Subject: Response to Noise Issues for Nordahl Tentative Map, County of San Diego Record ID PDS2015-TM-5602, Environmental Log No. PDS2015-ER-08-008

ACOUSTICAL ANALYSIS REPORT

Nordahl Major Subdivision 1217 Nordahl Road Escondido, California 92026

Original Report: June 5, 2017 Second Iteration: October 24, 2017

Figure 8

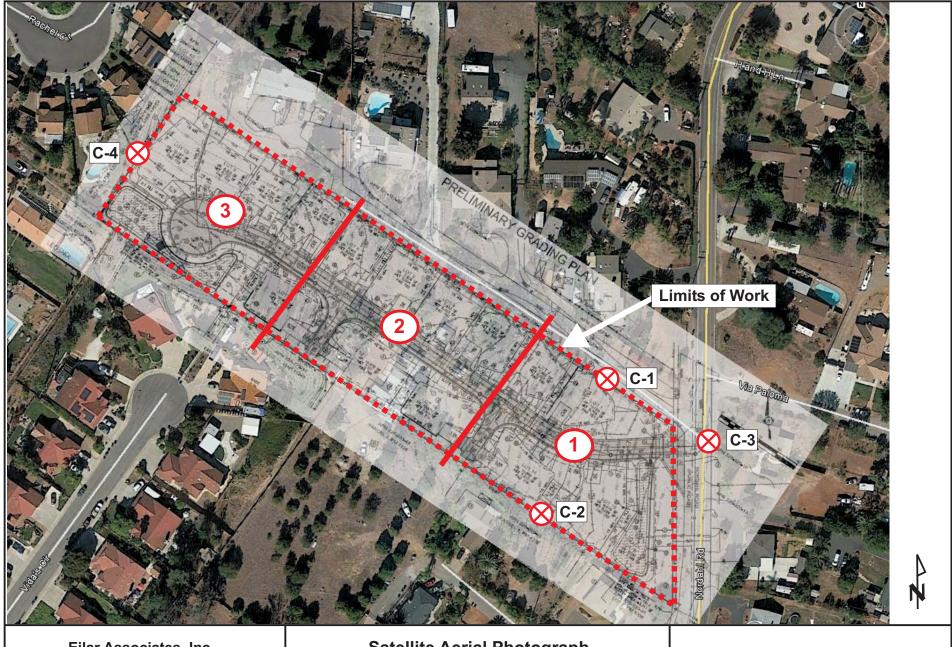
14-8. Please show a noise protection easement on the TPM over Lots 1, 2, 14, and 15.

RESPONSE: As requested, the applicant will include the noise protection easement, as indicated on Figure 8 of the letter, on the TPM for the project. A statement has been added to Section 2.2.1.2 reiterating this requirement.
